BUILDING CODE OF AUSTRALIA COMPLIANCE OVERVIEW REPORT

IZAKAYA RESTAURANT AND PIZZA SHOP

1 FRIDAY DRIVE, THREDBO

REPORT NO. ► 12480 Rev.00 [Izakaya]

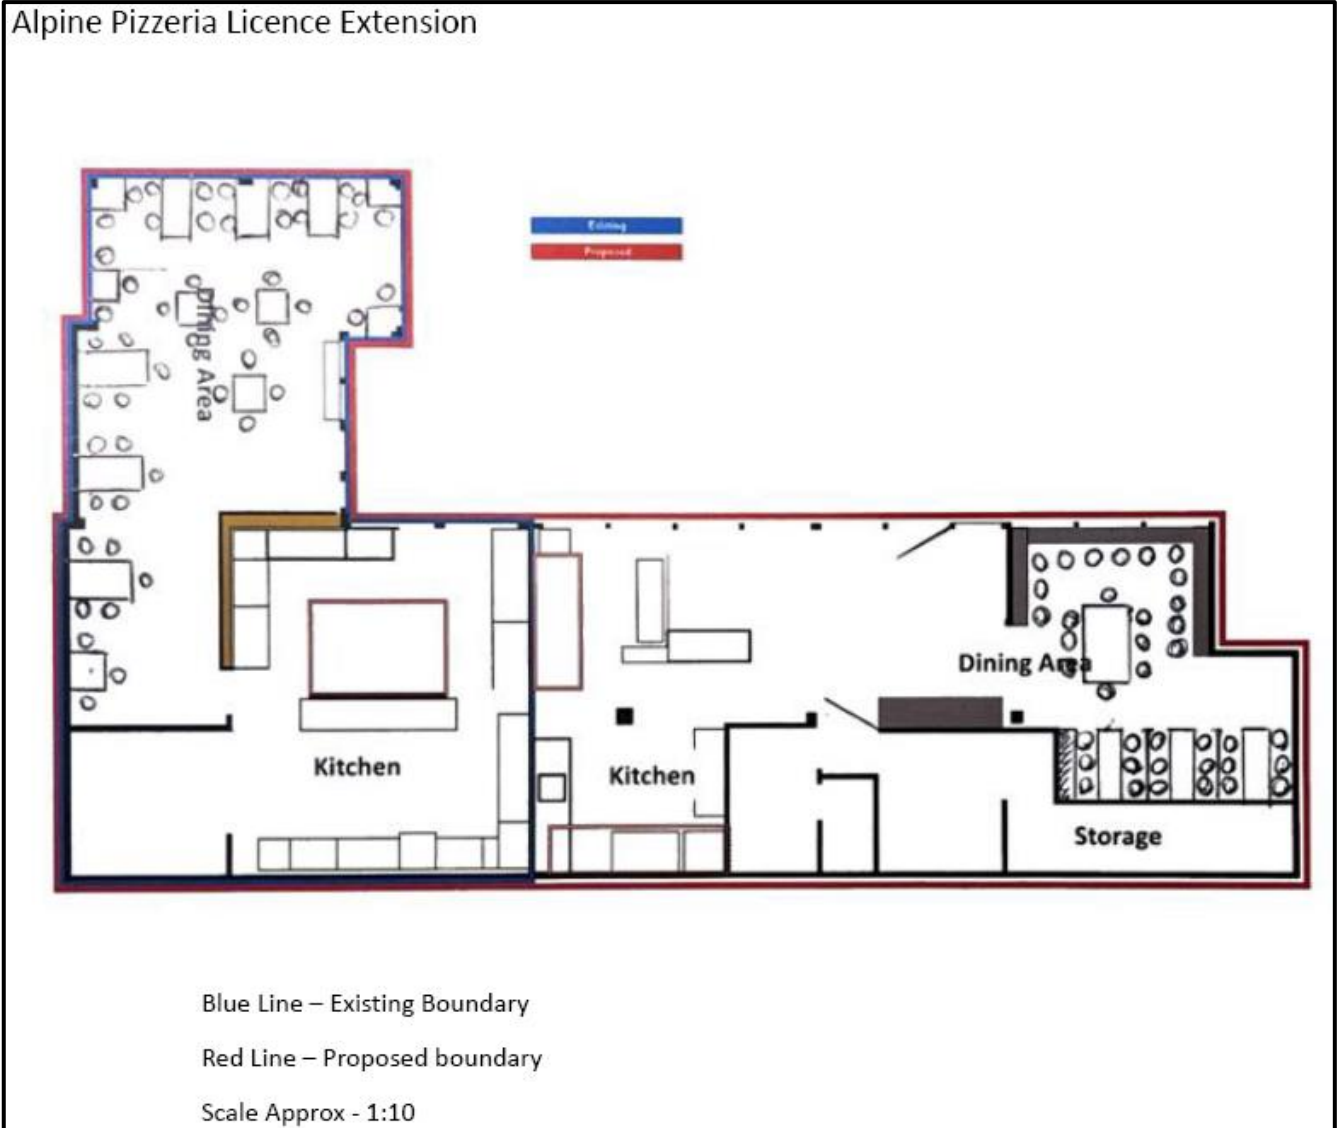
BCA Clause	Deemed-to-Satisfy Provision to be addressed	Photo Example
<p>Openings for services in fire rated construction</p> <p>BCA C4D15</p>	<p>Except where contained in fire isolated shafts, as per item below, penetrations in the floor in all services cupboards must be fire stopped in accordance with BCA C4D15 and Specification 13.</p> <p>The areas to be upgraded are:</p> <ul style="list-style-type: none"> - Downlights to be provided with fire rated covers. - Penetrations in the fire rated walls between the retail and hotel areas. - Fire rate conduits from rear storeroom with fire collar in Izakaya tenancy. - Repair existing fire collars installed in rear storeroom of Izakaya tenancy - Remove redundant mechanical ductwork and fire rate opening. - The fire dampers within the existing ductwork, must be checked for compliant operation and verified by the fire safety assessor as operational, if not to be rectified/ replaced for compliance with AS 1682. - The exhaust ducts running to the ceiling and to the roof must also be contained within a fire rated shaft and not discharge closer than 3m to another opening within the building.

<p>Widths of paths of travel</p> <p>BCAD2D8</p>	<p>Some existing paths of travel have widths of less than 1m. The BCA requires 1m.</p> <p>Performance solutions are proposed to address these issues.</p>
